# Office Action Summary

09/673,614

GRIMALDI ET AL.

### DETAILED ACTION

Attachment 2. W.H. Mollee - US 3,115,379

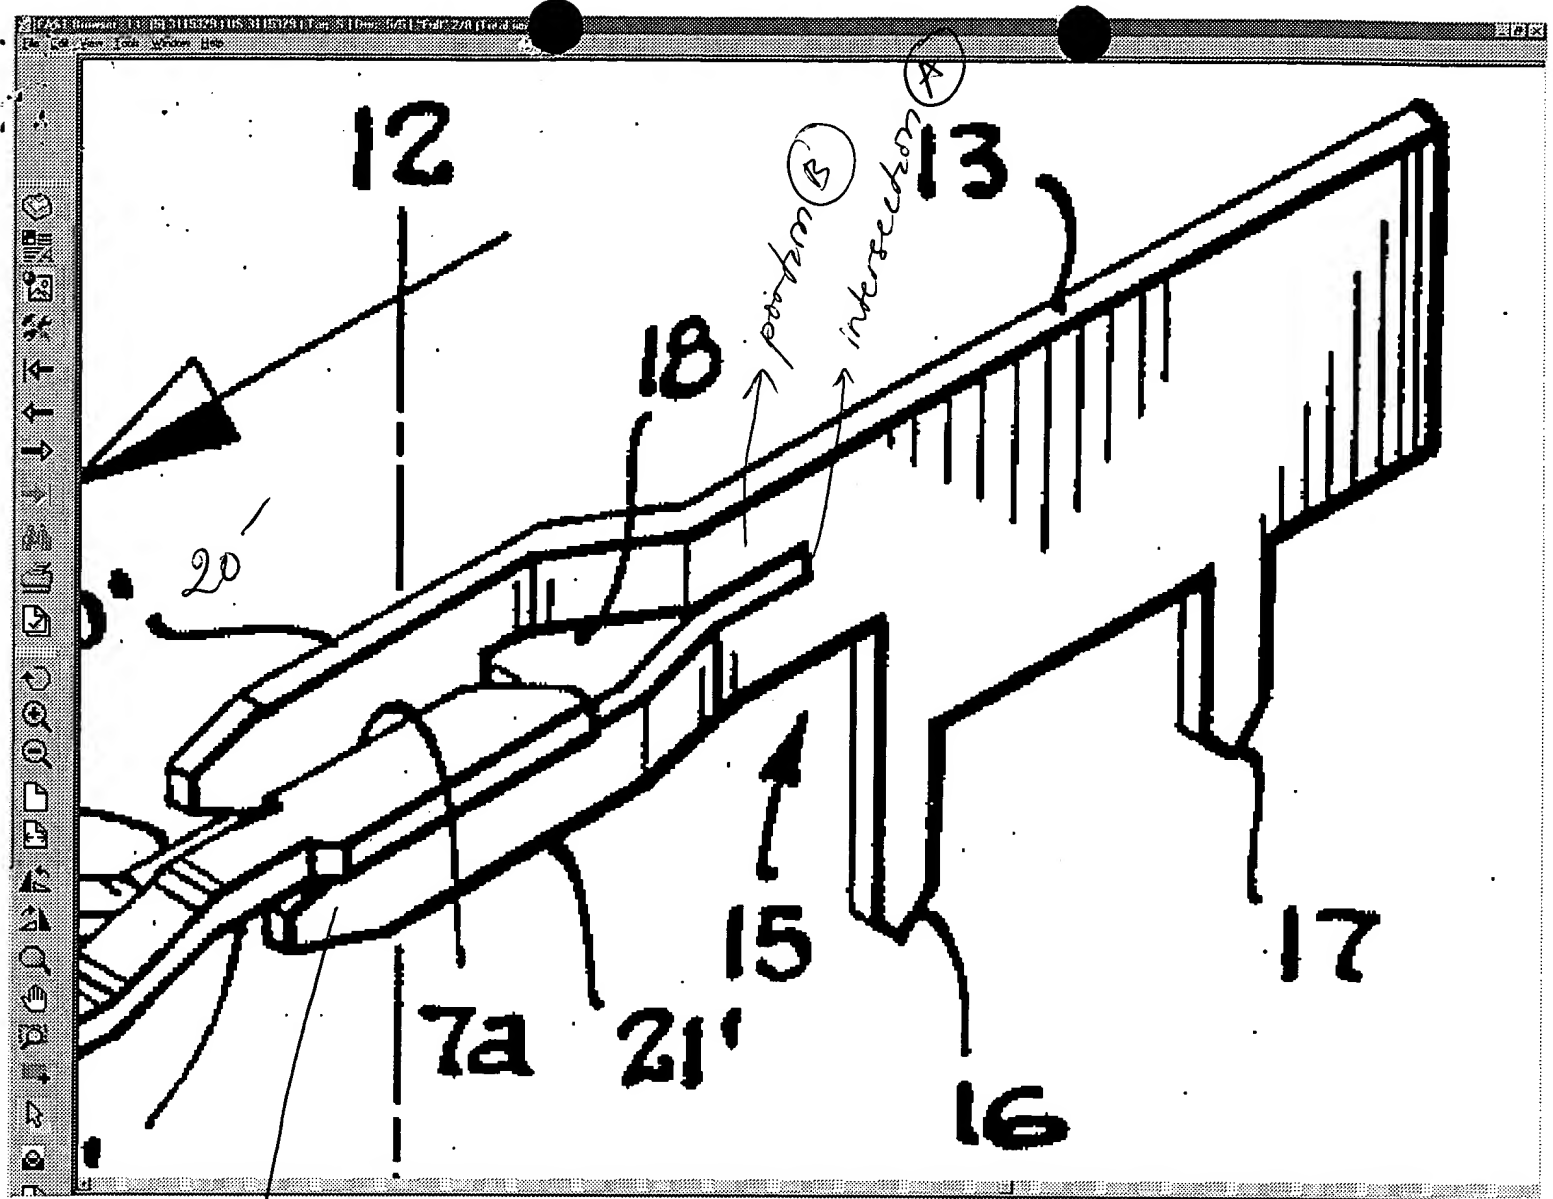
In regard to claim 1, W. H. McKee discloses (attachment 2) a spring contact (15) for use in a connector, which spring contact (15) is substantially U-shaped and has two branches (20', 16) and a base (13) joining the first and second branches (20', 16) at one end for forming a U-shape, and wherein each of the first and second branches (20', 16) complete an electrical connection with a device (contact at 1 inside a device), characterized in that the first and second branches (20', 16) lie in two diverging planes. The intersection (A) of the two planes (20', 16) is within the base (13) of the U-shape, and the first branch (portion B of 20') and the base (13) are coplanar.

In regard to claim 3, W. H. McKee discloses (attachment 2) the spring contact (15) characterized in that the electrical contact of at least one branch (20' or 16) is at the free end (C) of the branch (20' or 16).

In regard to claim 4, W. H. McKee discloses (attachment 2) the spring contact (15) characterized in that one of the first and second branches (16) is adapted to come into contact with a printed circuit (25) and the other of the first and second branches (20') is adapted to come

In regard to claim 5, W. H. McKee further discloses (attachment 2) an electrical connector comprising a first face (where 20' located) and a second face (where 16 located) opposite the first face (where 20' located), and at least one housing (it is inherent) for receiving a spring contact (15) and opening onto both of the first and second faces (where 20' and 16 located), wherein the spring contact (15) is positioned in the housing (it is inherent) so that a plane containing a base (13) of the U-shape is substantially parallel to the respective planes of the faces (where 16 located) of the connector.

In regard to claim 7, W. H. McKee discloses (attachment 2) the connector further comprising a retainer (housing) for retaining the spring contact (15) in the housing.

In regard to claim 14, in further limit of claim 1 based on attachment 2, W. H. Mokee discloses (attachment 2) the first branches (20') make electrical contact with a first device (contact at 1 of the device), and the second branches (16) make electrical contact with a second device (circuit board)(figure 15).

In regard to claim 15, W. H. McKee discloses (attachment 2) the connector characterized in that the electrical contact (15) of at least one branch (20') is at the free end (C) of the branch (20').

In regard to claim 16, W. H. McKee discloses (attachment 2) the spring contact (15) characterized in that the second branches (16) is a printed circuit (figure 15) and the first branches (20') is a battery; The shape of the contacts allows contact with theses devices. They are therefore seen to be adapted to do so.

Attachment 3

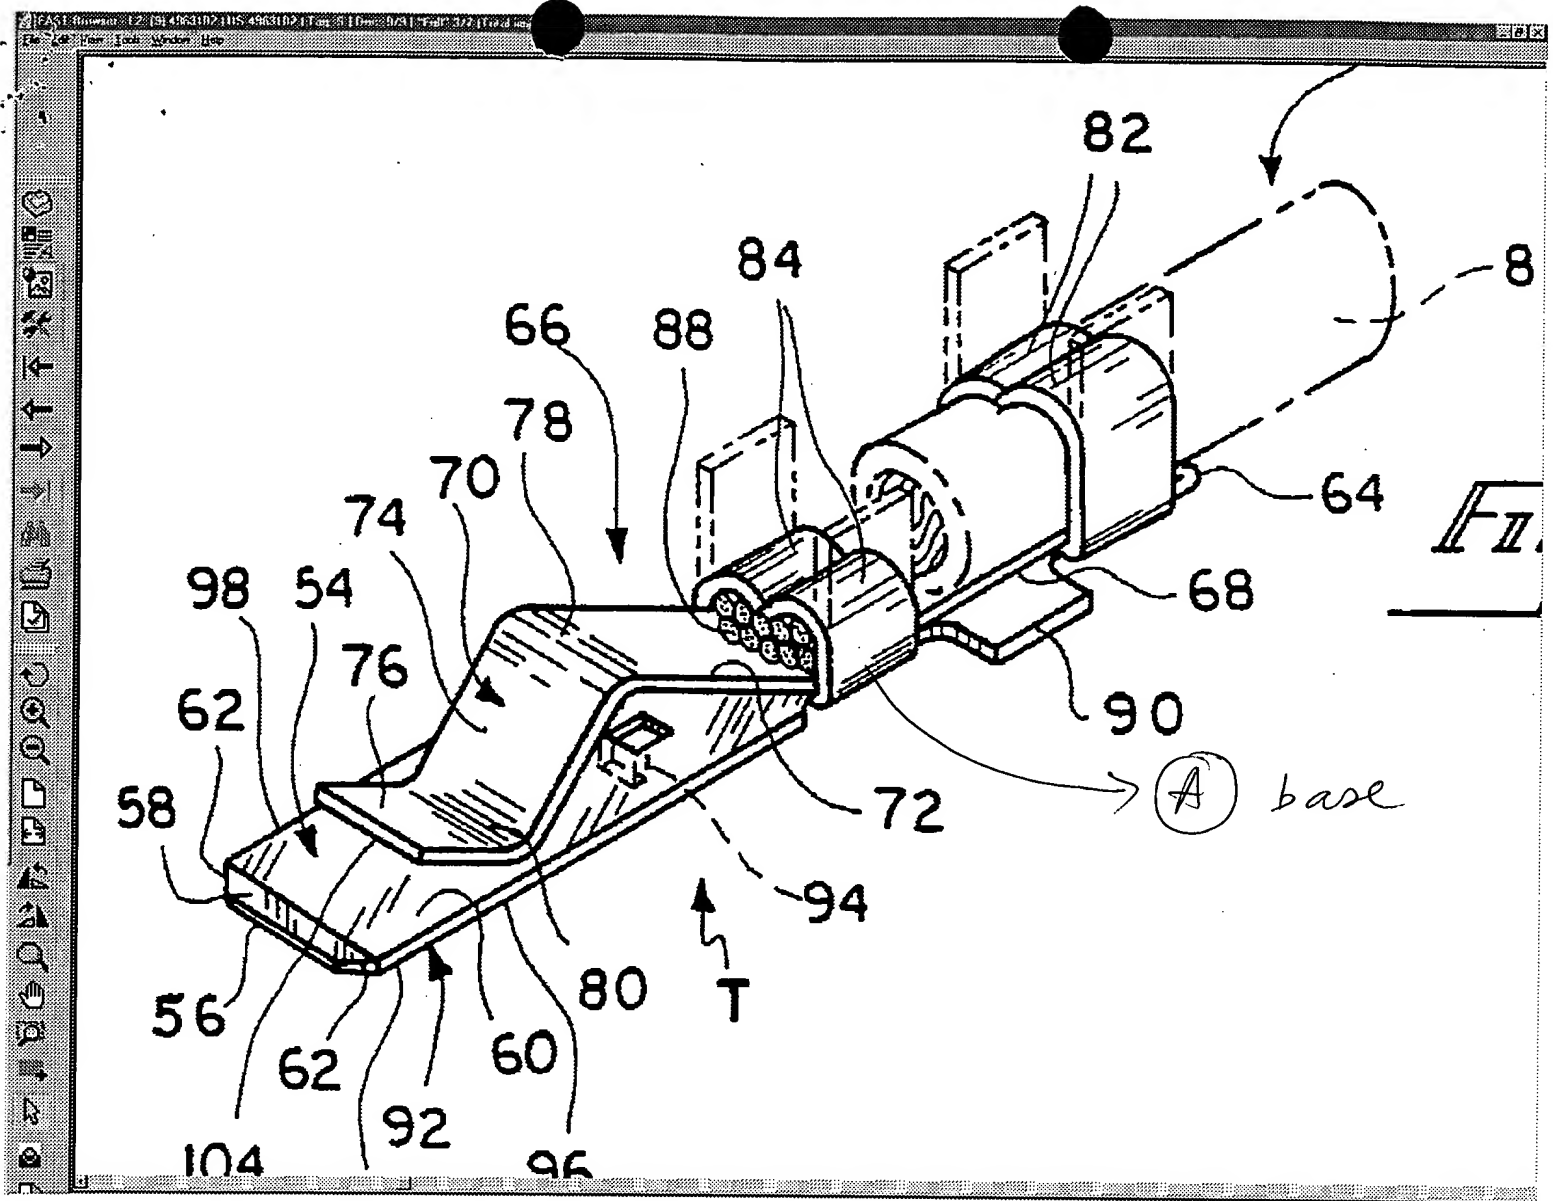
In regard to claim 1, Gettig et al discloses (attachment 3) a spring contact (T) for use in a connector, which spring contact (T) is substantially U-shaped and has two branches (54, 70) and a base (A) joining the first and second branches (54, 70) at one end for forming a U-shape, and wherein each of the first and second branches (54, 70) complete an electrical connection with a device (contact to mating contact), characterized in that the first and second branches (54, 70) lie in two diverging planes. The intersection of the two planes is within the base (A) of the U-shape, and the first branch (54) and the base (A) are coplanar.

In regard to claim 3, Gettig et al discloses (attachment 3) the spring contact (T) characterized in that the electrical contact of at least one branch (54) is at the free end (56) of the branch (54).
